APPENDIX B

Lighting Study

Lowe's Parking Lot Lighting Study
City of Manteca, CA
Prepared by Auerbach Glasow

March 2007 Lighting Study

Appendix B-2 – Site rendering and calculation – Plan View at Northeast Corner

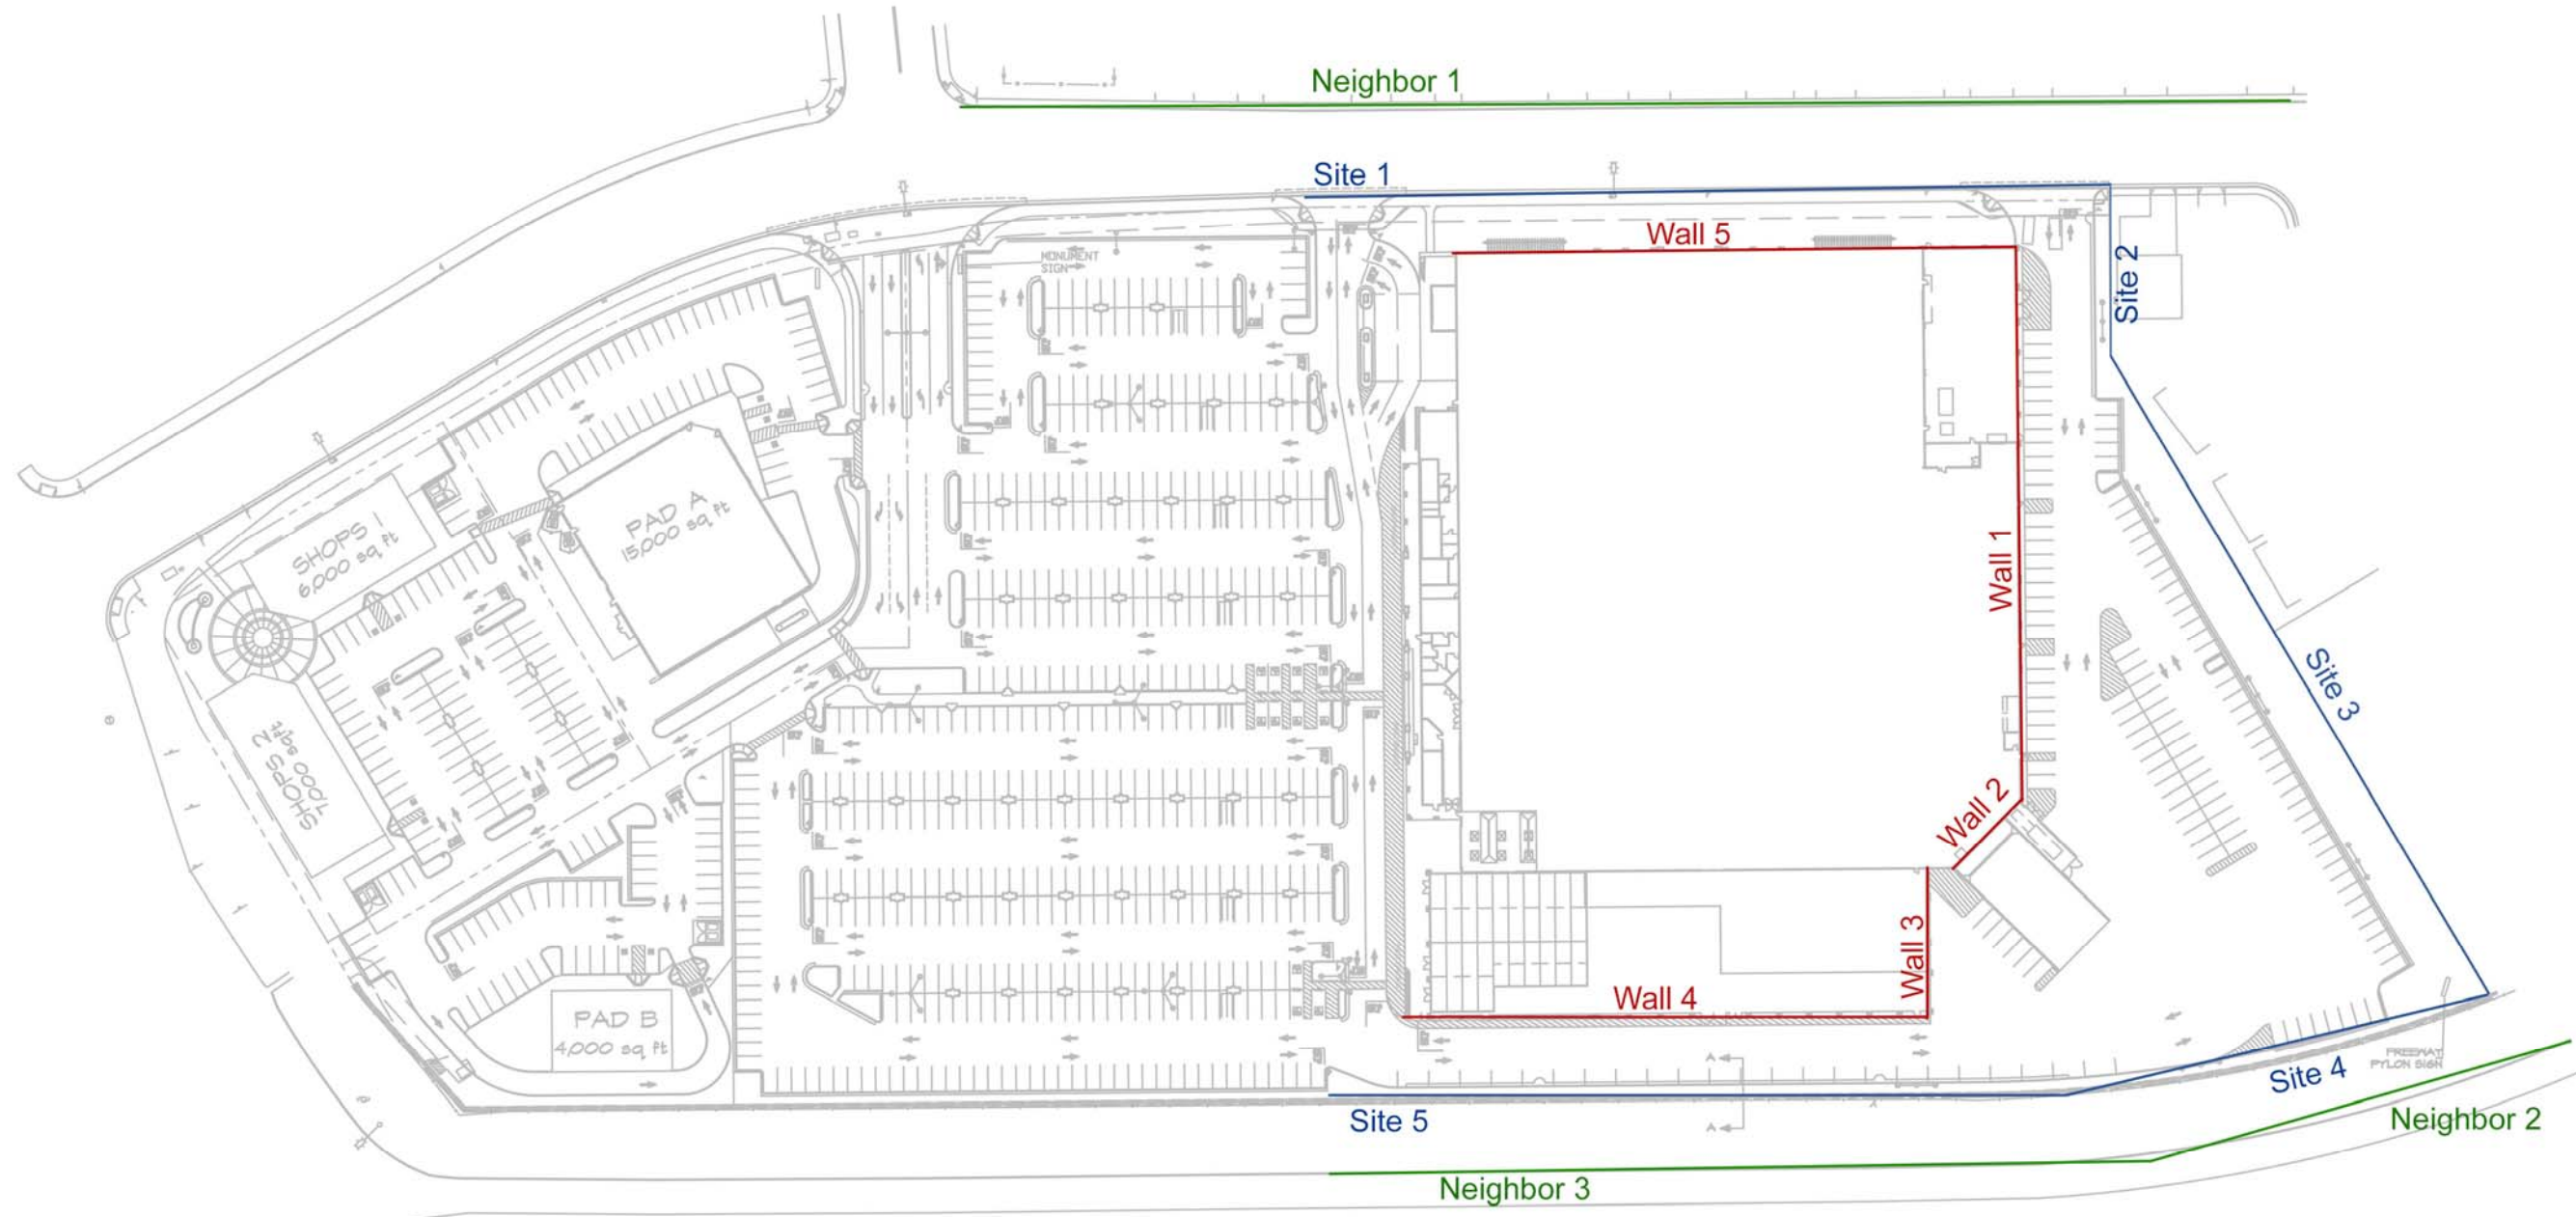
- Average maintained light levels exceed recommended practice by about 300%.
- The revised layout effectively integrates the lighting and landscape.
- Indirect glare from wall mounted fixtures is caused by high light output towards the wall.
- Wall fixtures are lamped at a much higher wattage than necessary
- The northeast corner of the site is significantly underlit

- Reduce lamp wattages on all pole fixtures 400W to 250W.
- Reduce lamp wattages on all wall mounted fixtures to 150W.
- Include glare shield with all type WL and WL-250 fixtures to reduce back splash.
- Add one to two fixtures at the northeast corner of the site to improve light levels.

Appendix B-1 – Site rendering without trees – Plan View

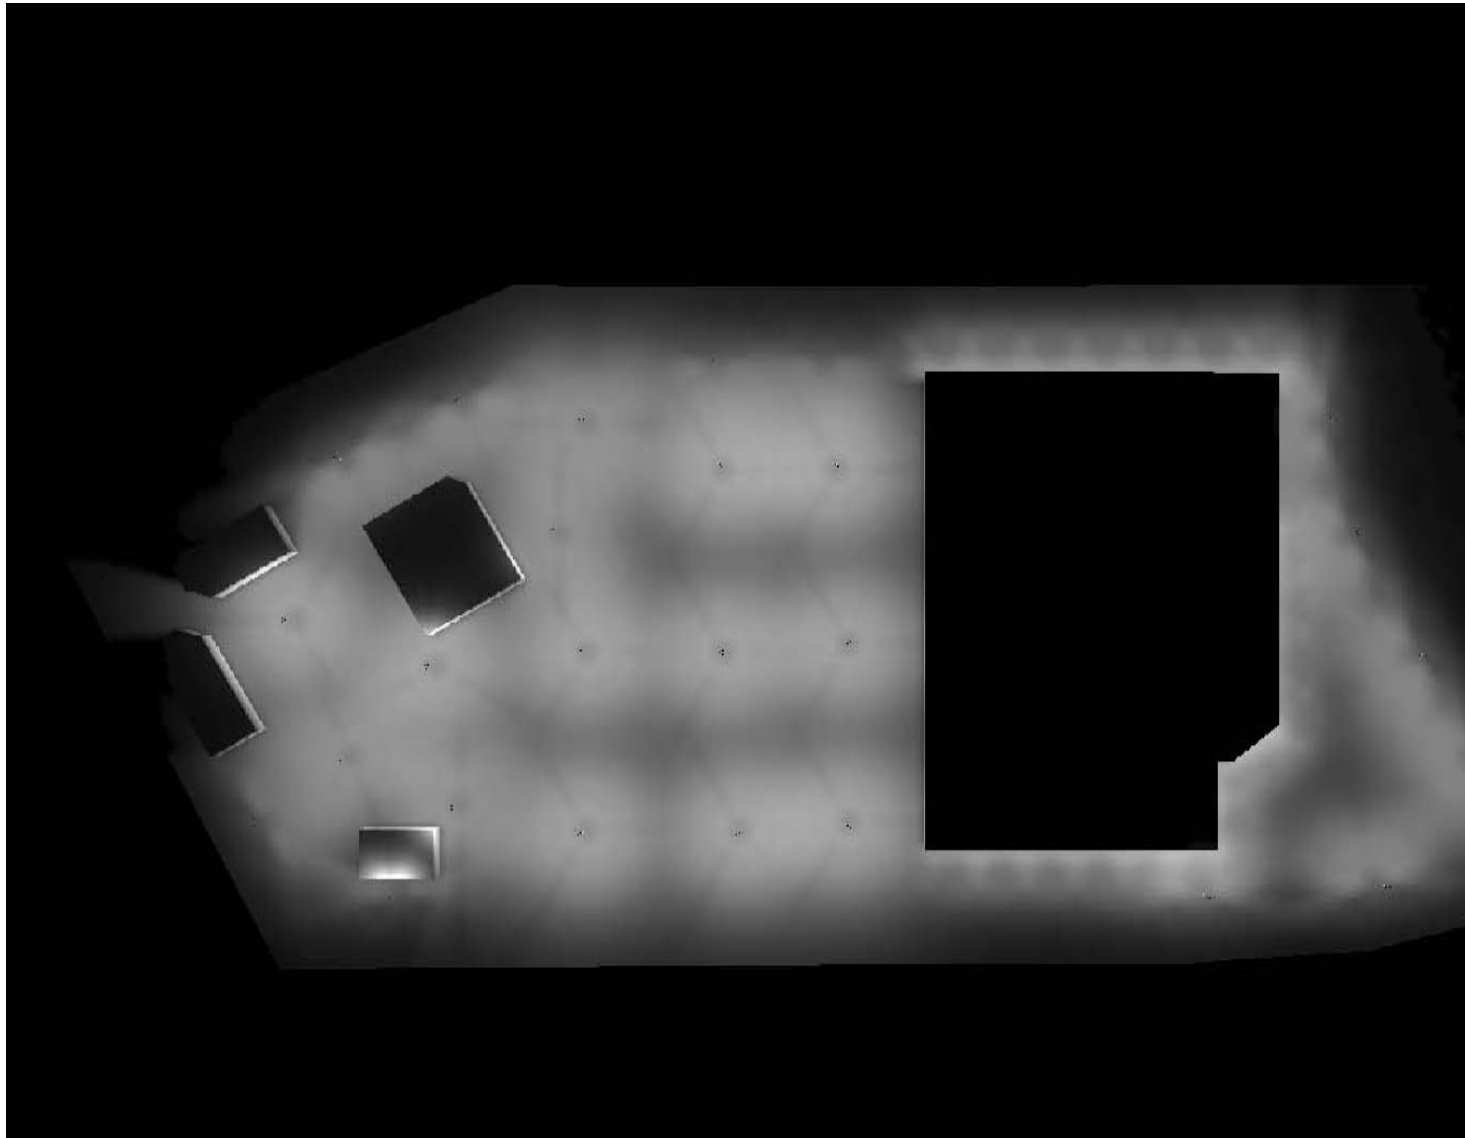
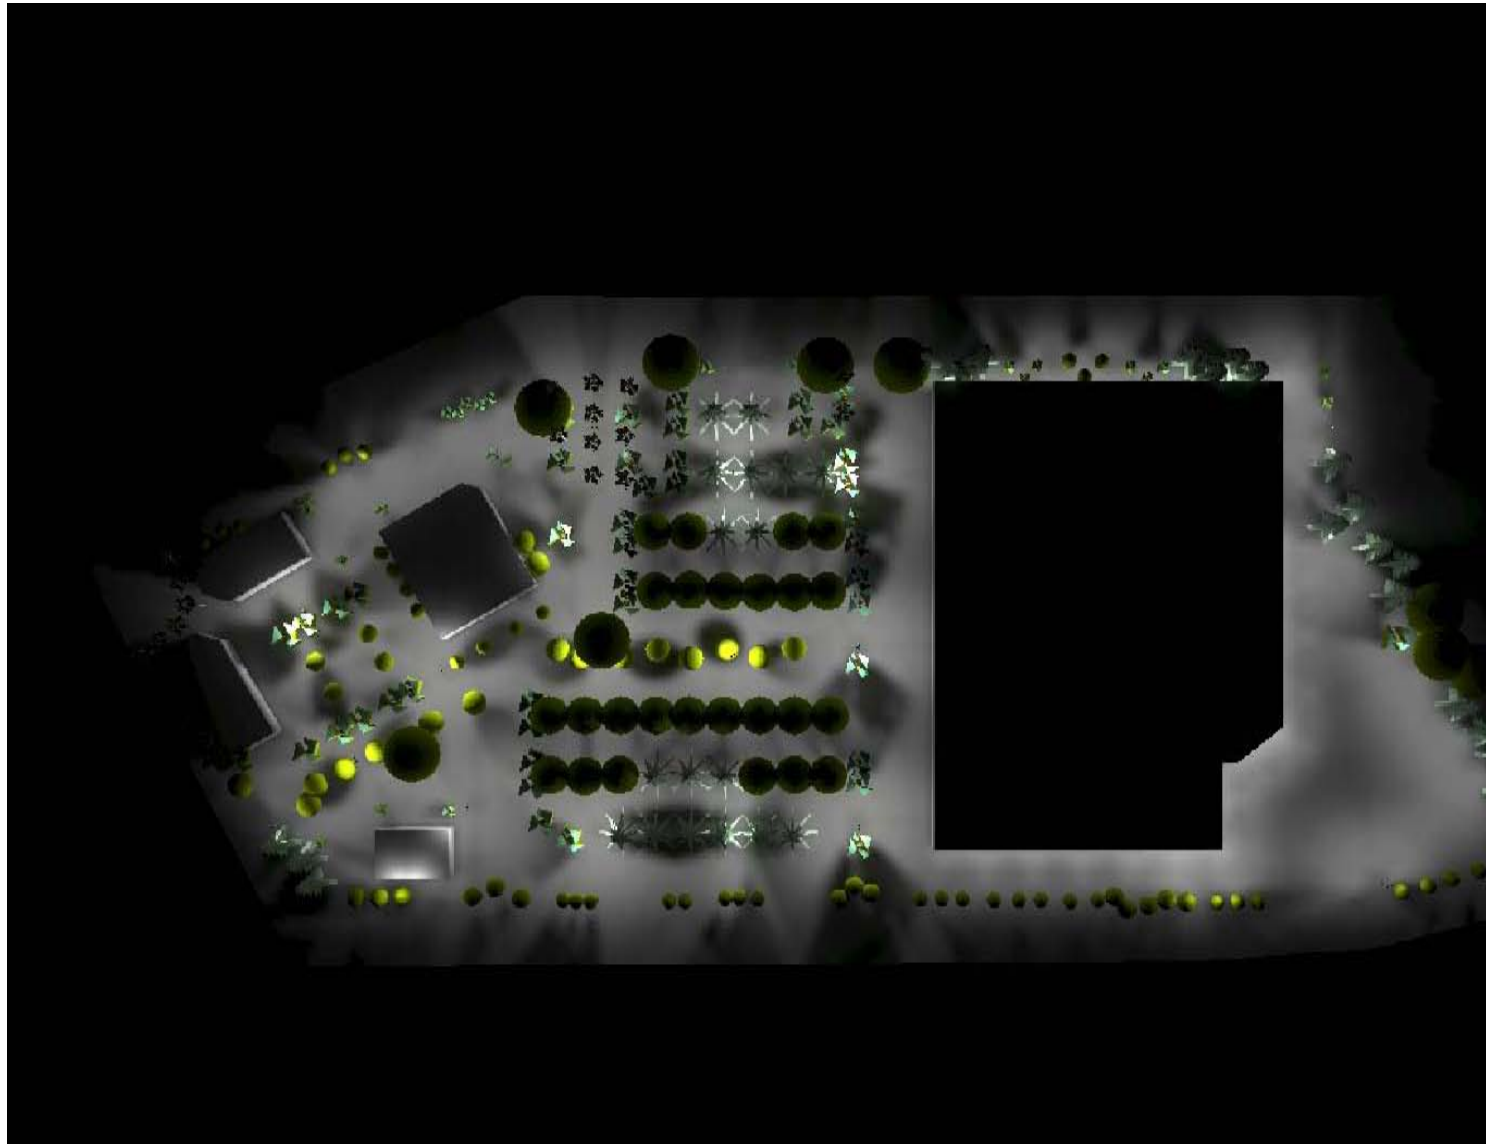
- Initially, minimum light levels exceed recommendations by 350-400% and higher, with average light levels exceeding recommendations by about 600%.
- Once landscaping grows to full maturity, minimum light levels and uniformity ratios will not be met in some areas.
- Pole fixture locations have a high maximum candela angle, posing a glare problem when oriented towards the site boundary.
- Indirect glare from wall mounted fixtures is caused by high light output towards the wall.
- Task 2 will be necessary for project to meet IESNA recommended practice.

Two calculation sets were performed for the site. The first set was run without landscaping, as an assumption of winter conditions and newly planted trees [Appendix B-1]. The second set [Appendix B-2] contains tree models [Appendix C], to assess the effectiveness of the lighting system with trees grown to full size. The results of these calculation sets are summarized and compared to the recommended criteria in Table 2. Values that fail to meet the criteria are shown in red. In general, light levels far exceed requirements, except where light is directly occluded by foliage.

- Reduce lamp wattages from 400-1000W to 150-400W.
- Pursue alternate fixtures for type WL to reduce back splash and high angle light.
- Redesign pole layout to coordinate with landscaping.
 - Redesign may include changes to pole height and arm length.
- Orient pole fixtures away from site boundary to reduce light trespass.
- Run computer calculations to confirm the effectiveness of the above revisions.
